KENYA ELECTRICITY GENERATING COMPANY PLC

TENDER No. KGN-GDD-052-2019

TENDER FOR SUPPLY OF CIRCUIT BREAKERS AND TOOLS FOR OLKARIA 2 POWER STATION.

CLARIFICATION No. 1

Figure 1 ACB chassis photo

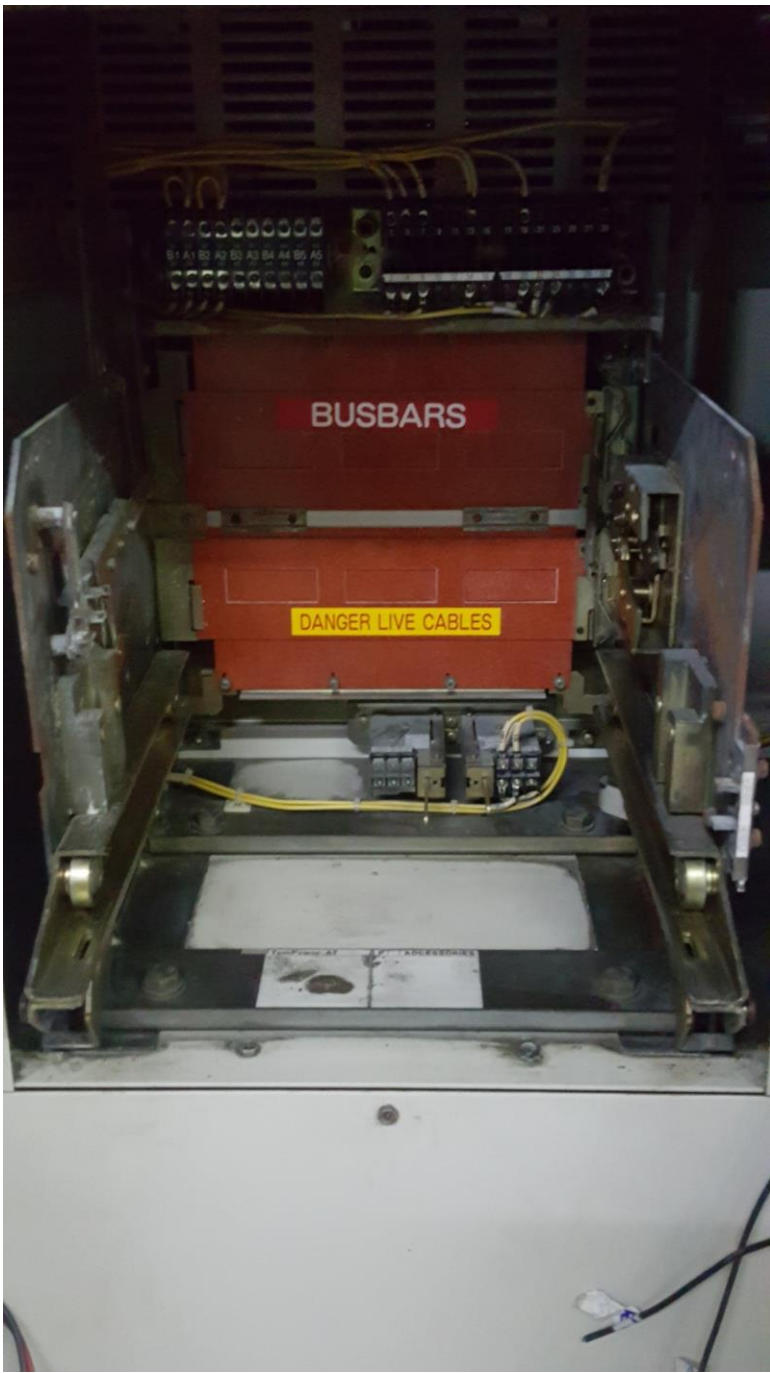
NO.	BIDDERS QUESTION	KENGEN'S RESPONSE
1	Is the ACB Chassis having Horizontal Terminal Connections? Please confirm?	The ACB chassis has horizontal terminal connections. Please refer to the photograph shown below. The Chassis has female horizontal connections.
2	Please confirm the full spec of the ACB?	Full specifications of the ACB are as in the tender document. Attached is the nameplate of the circuit breaker to be retrofitted.
3	We would need to know if system is 3 phase 3 wire or 3 phase 4 wire. Please confirm?	The system is 3-phase 4 wire but the ACB is 3 Pole.
4	We need to know the system voltage. Please confirm?	System voltage is 415V
5	Dead bus bars would be required for this work to be carried out with full custodial locking of the switching device being carried out by Terasaki engineers.	Safety measures will be agreed upon by all parties when the work commences and this will be at site. By all parties we mean both the contractor and the client.

6	Please send photos of the ACB panels including the Chassis Terminal Connection to the Bus Bars.	Photos are herein attached. Page 2 is the ACB chassis photo, page 3 is the ACB namelate and page 4 is the ACB showing it's male horizontal connections.
